Access Compliance Report

Public Rights-of-Way

Intersection ID: 44929	Main Street: TWIN_BROOK_DR	Cross Street: NATHAN_DR	Location: SW
ADA ID: CF3DCF2F291C	Ramp Type: Perp	Initial Pass/Fail: Fail	Overall Compliance: No
Severity Score: 8.75			
Codes/Mitigation Info/Possible Solution		Field Measurements/Component Compliance

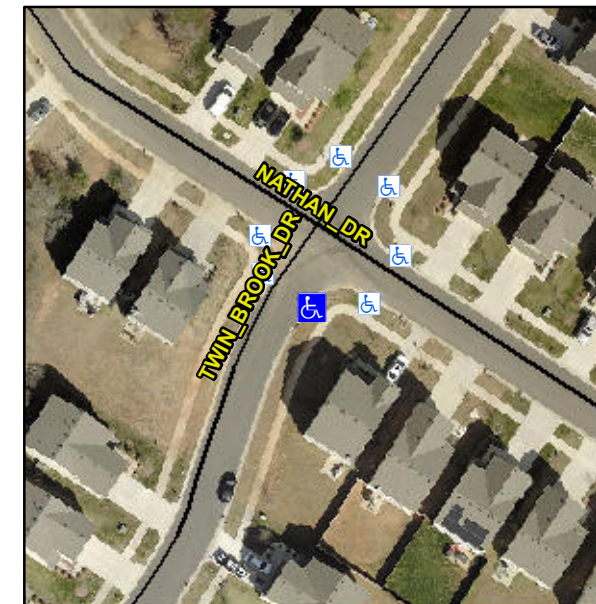
Not Found, R304.5.1

Compliance	Description	Data	Compliance	Description	Data
N/A	Ramp Length (in)	95.5	Yes	Ramp Slope (%)	6.4
No	Ramp Width (in)	38.5	Yes	Ramp XSlope (%)	0.7
N/A	Flare Type LT	N/A	N/A	Flare Type RT	N/A
N/A	Flare Slope LT (%)	N/A	N/A	Flare Slope RT (%)	N/A
N/A	Flare Traversable LT?	N/A	N/A	Flare Traversable RT?	N/A
N/A	Landing Length (in)	N/A	N/A	DWS Provided?	N/A
N/A	Landing Width (in)	N/A	N/A	DWS Contrast?	N/A
N/A	Landing Slope (%)	N/A	N/A	DWS Length (in)	N/A
N/A	Landing X Slope (%)	N/A	N/A	DWS Full Width?	N/A
N/A	Landing Curb? (Y/N)	N/A	N/A	DWS Offset (in)	N/A
N/A	Shared Landing?	N/A			
N/A	Gutter Ponding?	N/A	N/A	Gutter Slope (%)	N/A
N/A	Gutter Lip Ht (in)	N/A	N/A	Gutter X Slope (%)	N/A
N/A	Painted X Walk1?	No	N/A	Painted X Walk2?	N/A
	X Walk 1 Direction	To NW		X Walk 2 Direction	N/A
N/A	X Walk 1 Width (in)	N/A	N/A	X Walk 2 Width (in)	N/A
	X Walk 1 Slope (%)	4.0		X Walk 2 Slope (%)	N/A
	X Walk 1 X Slope (%)	0.4		X Walk 2 X Slope (%)	N/A

Remove & Replace Entire Ramp.
